Hume Highway Upgrade

Tarcutta bypass

Environmental Assessment
Submissions Report

November 2009

Figure 3-1a Proposed design changes to the Tarcutta Bypass Project (northern section)

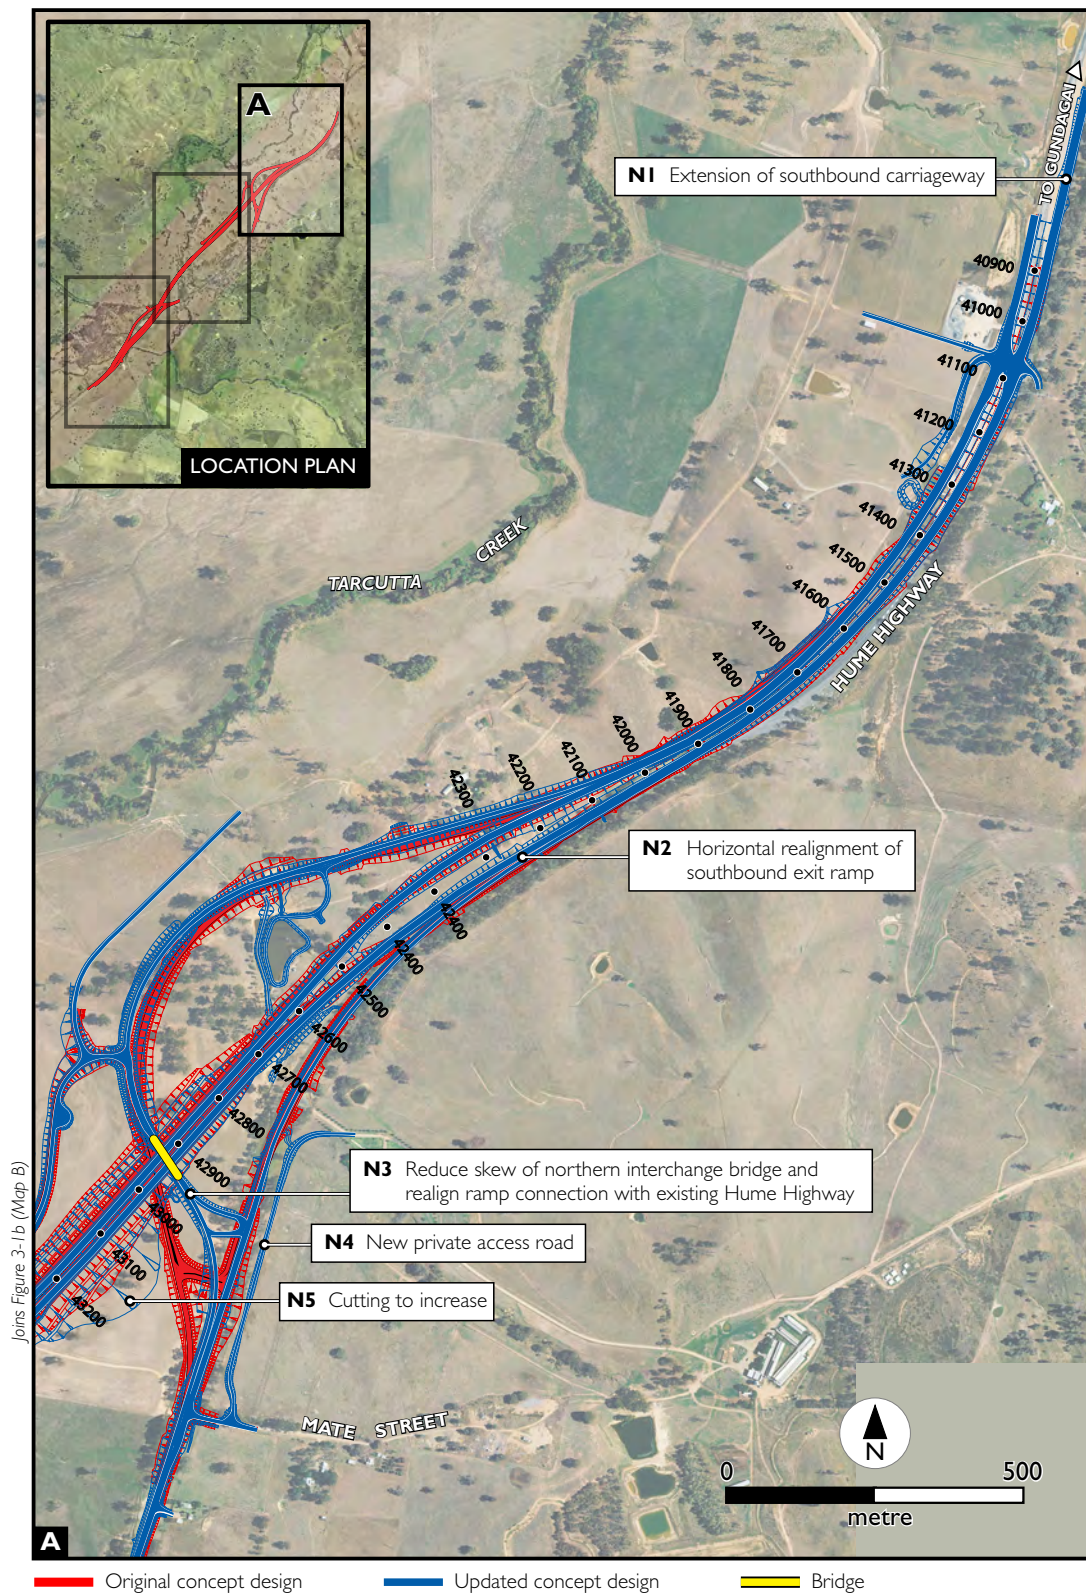
The proposed design changes are shown in Figure 3-1a and described below. For ease of identification, the design changes have been numbered.

Design change N5

The cutting two, located immediately to the south of the northern interchange bridge would be increased to accommodate the reshaping of the existing hill as part of urban design and provide a better earthworks balance reducing the volume of material that would need to be imported.

The proposed increase in excavation at cutting two (refer design change N5 in Section 3.2.1) would result in an increased volume of spoil. This increase in excavation does provide an opportunity for the project to come closer to achieving an overall balance of earthworks. Where practicable, the additional spoil would be re-used on site as fill in accordance with the principles of the *Waste Avoidance and Resource Recovery Act 2001*. If suitable, reuse of the

Figure 3-1b Proposed design changes to the Tarcutta Bypass Project (middle section)

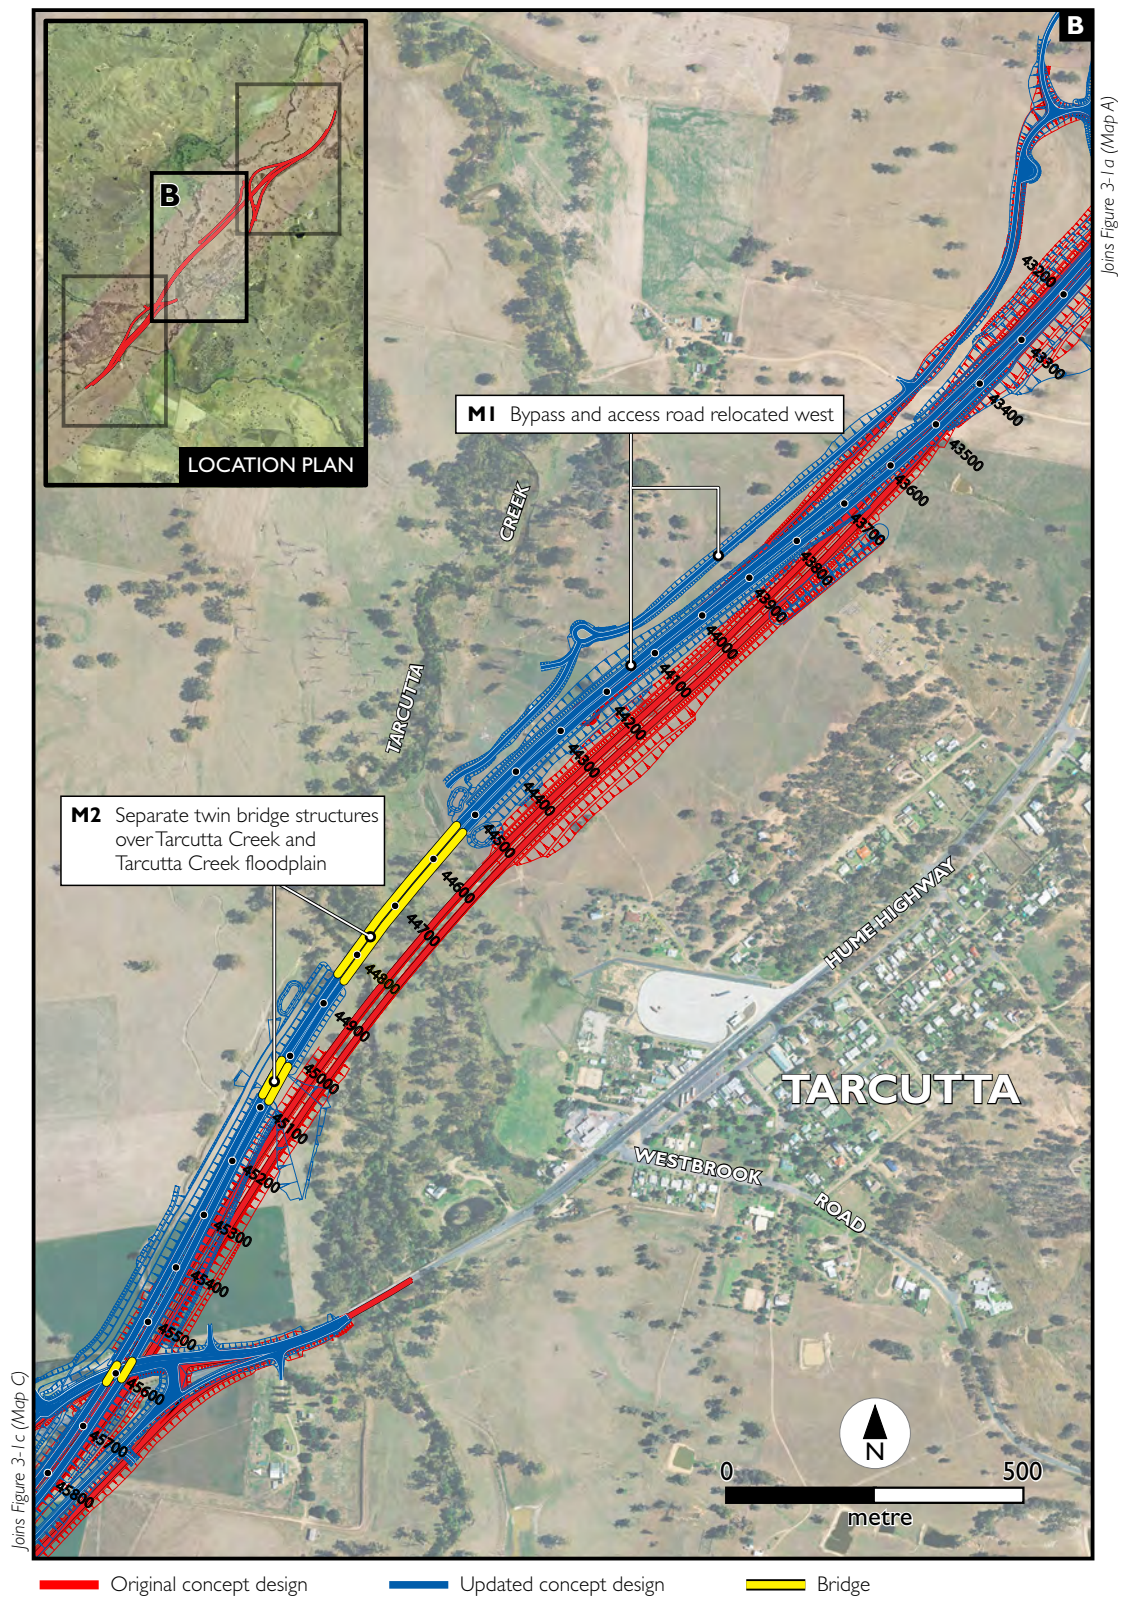
The proposed design changes are shown in Figure 3-1b and described below. For ease of identification, the design changes have been numbered.

Design change M1

The alignment has been shifted to the west by up to 80 metres between chainages 43500 and 46000 with a corresponding shift in the local access road. An access track would be provided from the end of the local road to provide permanent maintenance access to the bridges and water quality basins.

Design change M2

Bridging over Tarcutta Creek and floodplain has been rationalised to provide 330 metre long twin bridges over Tarcutta Creek between chainages 44524 and 44854 and 60 metre long twin bridges over Tarcutta Creek Floodplain between chainages 45016 and 45076.

The reconfiguration of bridging over Tarcutta Creek and floodplain (refer design change M2 in Section 3.2.2) has been assessed for potential impacts on flooding. The proposed design change would not result in any changes to construction related flooding impacts (refer Section 9.4.3 of the environmental assessment).

The revised alignment location (refer design change M1 in Section 3.2.2) would potentially reduce amenity impacts (noise, visual) of the project on sensitive receivers located to the east of the proposed bypass by increasing the offset distance between the road and the Tarcutta township by up to approximately 80 metres. The affect of the alignment shift on operational noise would likely be in the order of 0.5 – 1.0 dB for receivers located in ‘Zone 2’ to the east of the project (includes approximately 30 residences, refer to Section 9.5.1 of the environmental assessment). Around three sensitive receivers located to the west of the project may incur a similar increase in operational noise impact.

Figure 3-1 c Proposed design changes to the Tarcutta Bypass Project (northern section)

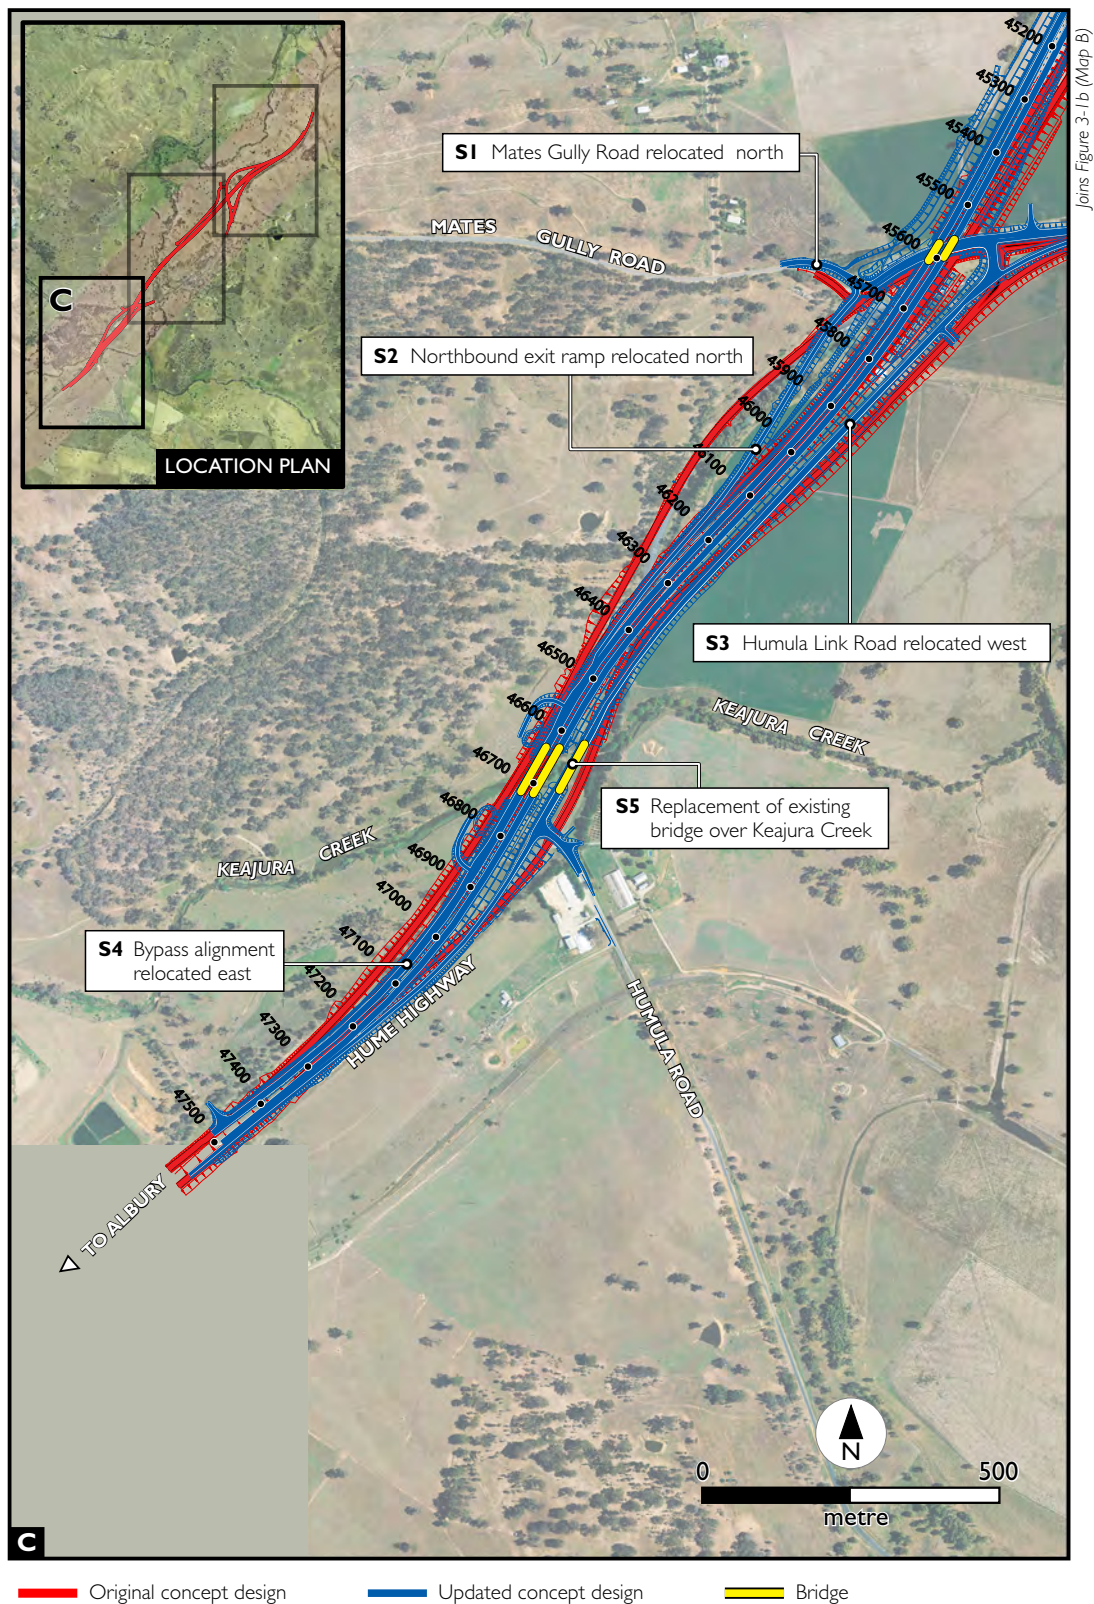
The design changes are shown in Figure 3-1c and described below. For ease of identification, the design changes have been numbered.

Design change S5

The bridge over Keajura Creek on the existing highway would be demolished and replaced with a new 70 metre long bridge constructed immediately to the west of the existing bridge. This new bridge would provide a crossing for the Humula Link Road.

The realignment of the Humula Link Road (refer design change S3 in Section 3.2.3) would include a westward shift of the project within the curtilage of the State heritage listed Hambledon Homestead Complex TH15 (refer Table 9-12 of the environmental assessment). This proposed design change would avoid the direct impact to the historic brick well (and associated windmill) and reduce the impact to the heritage curtilage of the Hambledon Homestead Complex. The historic brick well (identified as TH15a in the environmental assessment) and surrounding paddocks are considered to be of moderate contributory significance to the overall heritage significance of the Hambledon Homestead Complex.

The demolition of the existing Hume Highway bridge over Keajura Creek, and the construction of the new bridge immediately to the west (refer design change S5 in Section 3.2.3), would have the potential to result in short-term surface water quality impacts within Keajura Creek. As described in Section 10.1.3 of the environmental assessment, the soils within the vicinity of the proposed works – from the Umbango and Tarcutta Soil Landscape Units – have a very high erosion potential and shed run-off from most rainfall events. The dispersible nature of fine-particle silts and clays present in the soils means that the particles would remain in suspension for longer periods of time. Accordingly, there is a greater risk of sediment loads spreading considerable distance downstream of the proposed bridge works. Increased sedimentation of waterways can smother benthic habitat and organisms, and can increase levels of nutrients, metals and other potential toxicants that attach to the sediment particles.
